## **Group submission relating to application SSD 5878**

### **Sydney International Convention, Exhibition and Entertainment Centre Precinct – Mixed use Development in the Southern Haymarket Precinct (Concept Proposal) (SSD)**

#### **Summary**

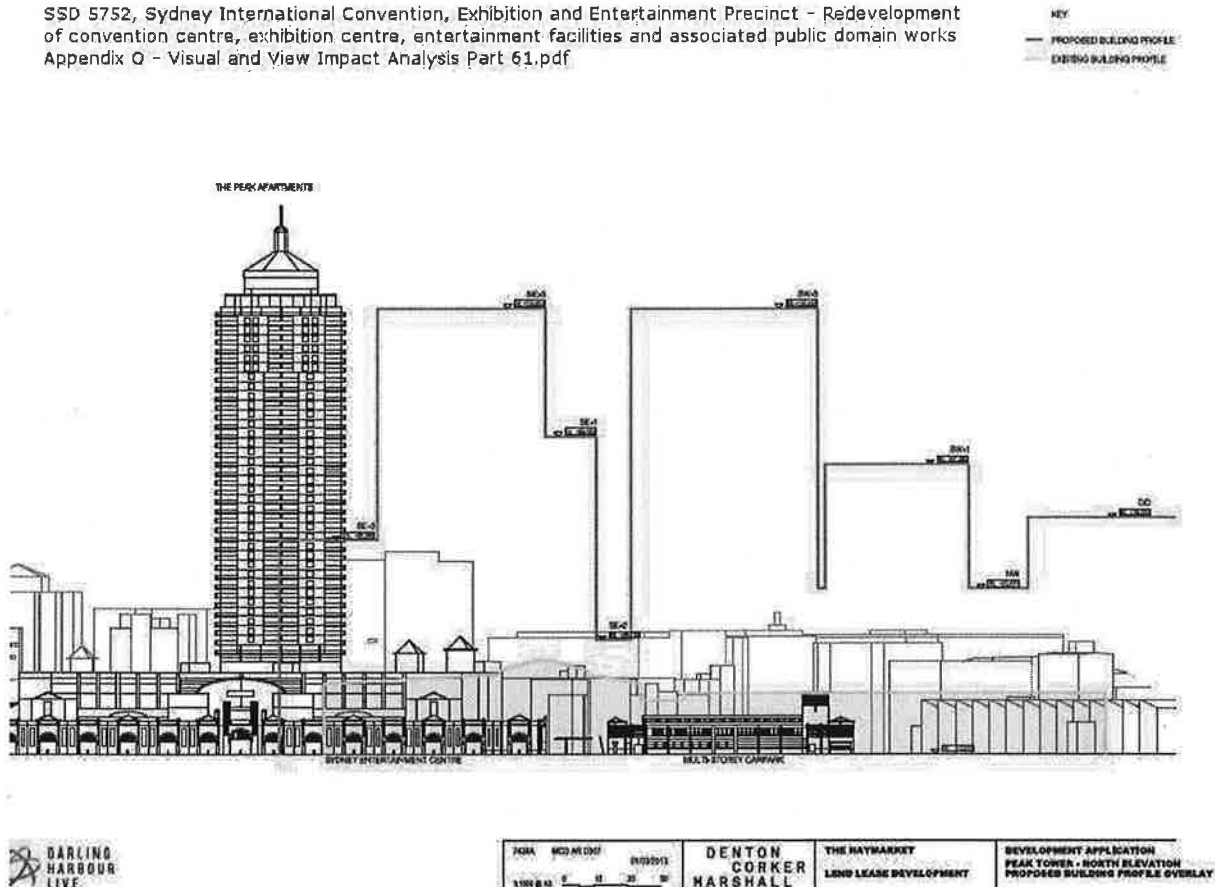
This shows these planning guidelines have been ignored in the drive for increased density and optimum placement of the new towers for maximum return - all with scant regard for the existing buildings.

The loss of amenities, outlook and views is an excessive burden on the residents of the Peak and for all the residents of surrounding buildings. At a minimum, it is imperative to delete the Tower SE1 from the planned development.

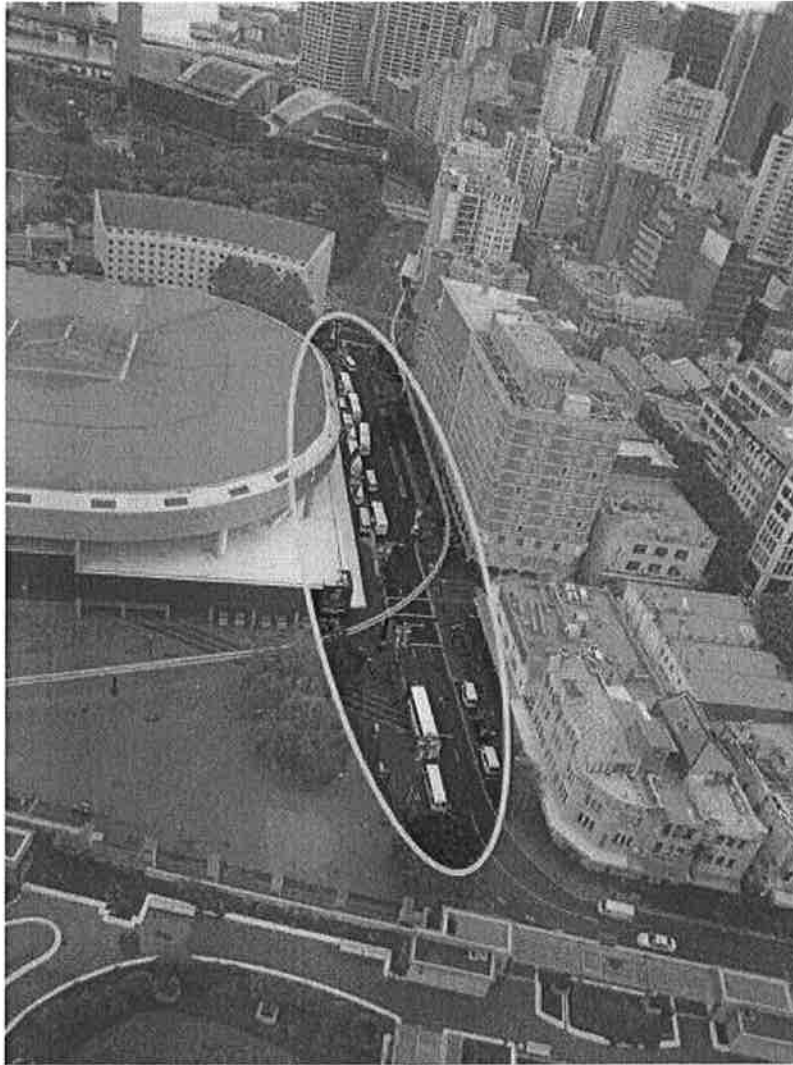
At present, tour buses line up each morning on Harbour Street to pick up tourists from the local hotels (The Holiday Inn, The Rockford Novotel, The Seasons and The Quest), for day trips and for the Airport run. There is space for about 6 buses. At the peak times there are often another 6 double parked, since they have nowhere else to go. Now this is to be reduced to 'No parking' or 'No Stopping'.

With the 2 entry points to the precinct on Harbour Street, this is going to generate severe problems for all parties.

Do we simply tell the tour buses to pick up elsewhere ? But where? Do we abandon our tourists?

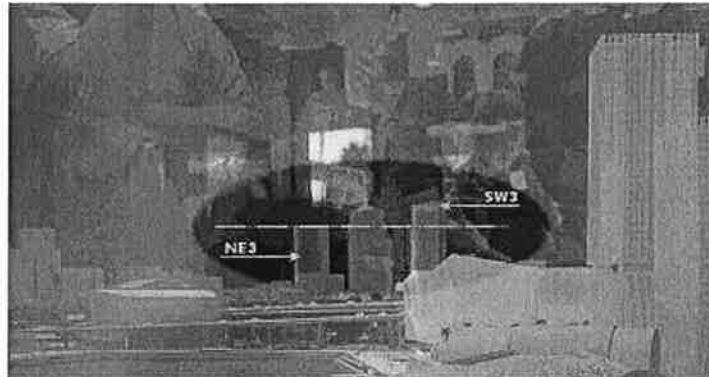
- *Views to the Powerhouse Museum will be affected by the two residential blocks in the Haymarket Precinct situated next to the Rail Corridor, which will also be impacted. Principal views to the Powerhouse Museum are available from Harris Street and will not be affected by the proposed development, while views to the building are of secondary importance.*

The student blocks and tower SW 1 will obscure the sight lines to the Museum from the southwest and the CBD. Why is it deemed sufficient to retain only the western façade when the eastern façade is the most important one.

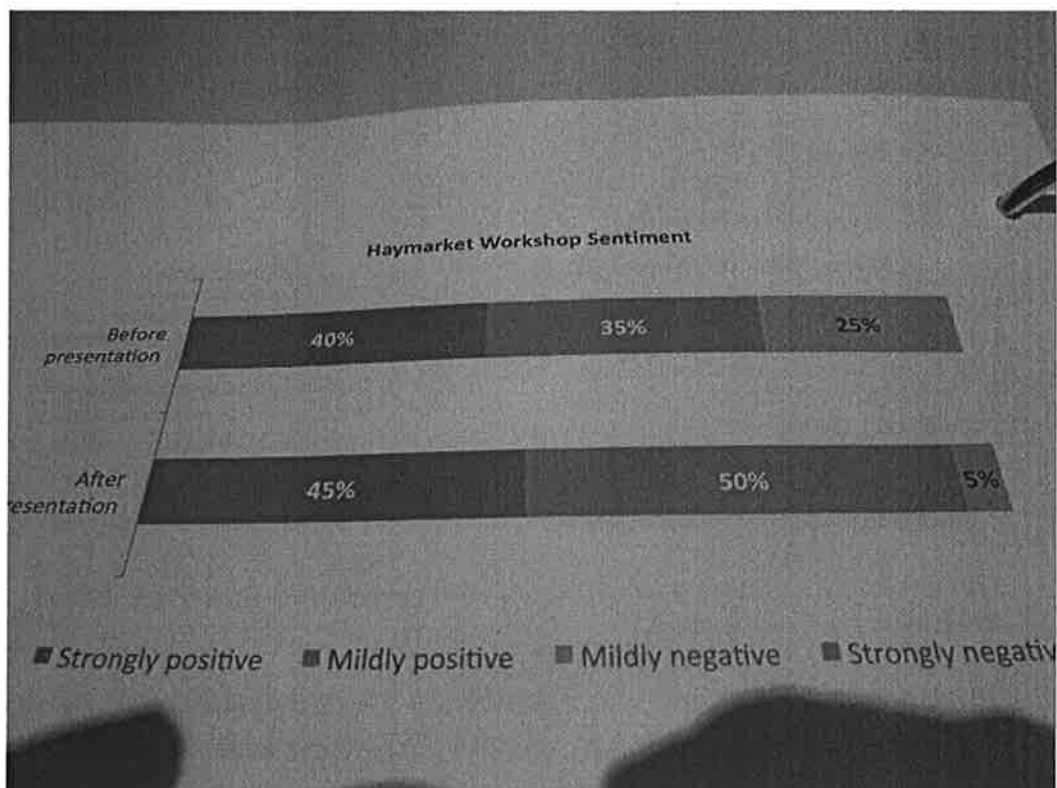
The information given during consultation was very much smoke and mirrors. The statements given on the height of the towers was vague and variable with the number of floors being defined from the podium level in some cases. The RLs of the top of the towers were not disclosed prior to the EIS being lodged. In fact tower NE3 grew about 8 floors after consultation. This is clear from photos of the original model.
